NOTICE OF AN APPLICATION FOR PLANNING PERMIT

The land affected by the application is located at:	140 Army Road, Pakenham VIC 3810 L1 TP518292
The application is for a permit to:	Development of land for nine (9) Dwellings on a lot and associated Works
The applicant for the permit is:	Draeh Planning
The application reference number is:	T230646
You may look at the application and any documents that support the application at the office of the Responsible Authority:	Cardinia Shire Council 20 Siding Avenue Officer 3809 This can be done during office hours and is free of charge. Documents can also be viewed on Council's website: https://www.cardinia.vic.gov.au/advertisedplanningapplications

PLANNING REPORT
140 ARMY ROAD PAKENHAM
MARCH 2024

Figure 1 - Current TPZ encroachment.

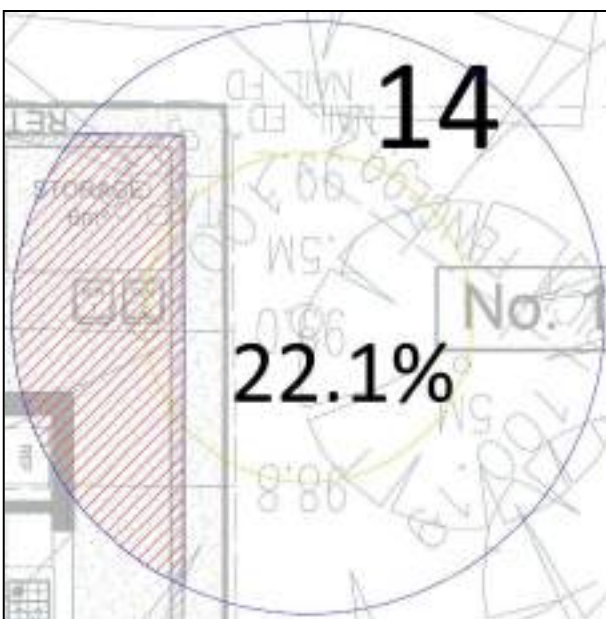
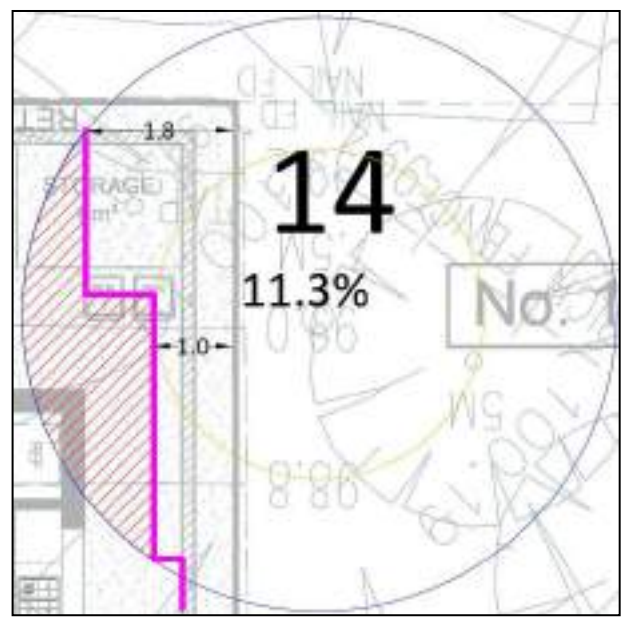
The plans provided indicate that a new retaining wall is proposed within the TPZ and SRZ of the tree. The retaining wall is likely to require excavation of greater than 800mm in depth. Given the extent of excavation and TPZ encroachment proposed, it is likely that significant root mass would be lost to install the retaining wall as currently proposed.

The retaining wall should be redesigned to reduce the TPZ encroachment.

Figure 2 - Recommended TPZ encroachment.
